Title of Change:	Added comments and corrected typos in LV8907UWR2G datasheet and application note.	
Effective date:	1 July 2019	
Contact information:	Contact your local ON Semiconductor Sales Office or <Kei.Nagai@onsemi.com>	
Type of notification:	This Product Bulletin is for notification purposes only. ON Semiconductor will proceed with implementation of this change upon publication of this Product Bulletin.	
Change Category:	<input type="checkbox"/> Wafer Fab Change <input type="checkbox"/> Assembly Change <input checked="" type="checkbox"/> Test Change <input checked="" type="checkbox"/> Other <u>Added comments in datasheet and application note</u>	
Change Sub-Category(s):	<input type="checkbox"/> Manufacturing Site Addition <input type="checkbox"/> Material Change <input checked="" type="checkbox"/> Datasheet/Product Doc change <input type="checkbox"/> Manufacturing Site Transfer <input type="checkbox"/> Product specific change <input type="checkbox"/> Shipping/Packaging/Marking <input type="checkbox"/> Manufacturing Process Change <input type="checkbox"/> Other: _____

Figure 5. Example Waveform

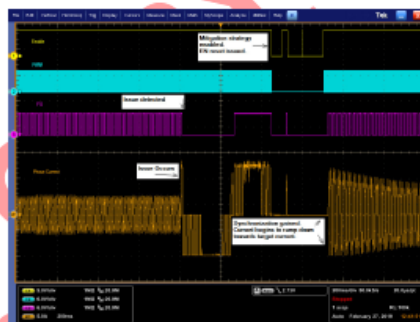
Figure 5 shows example waveform in the case that the commutation synchronization is lost. The coil current (Orange plot) shows abnormally high currents. FG pulse period changes drastically.

Figure 5 also shows example waveform of resynchronization by toggling EN pin. The EN pin should be set low immediately when incoherent FG pulse detected in an actual application.

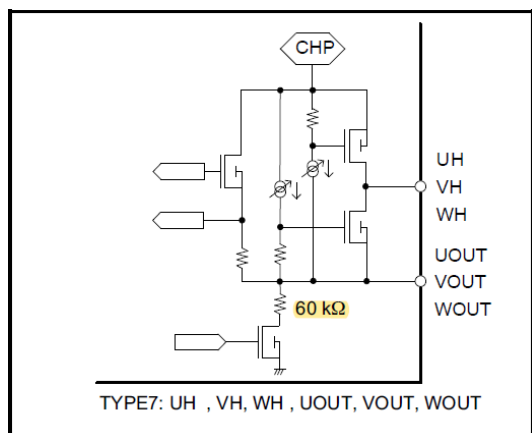
11. The resistance marked yellow in the schematic below must be 60kΩ.
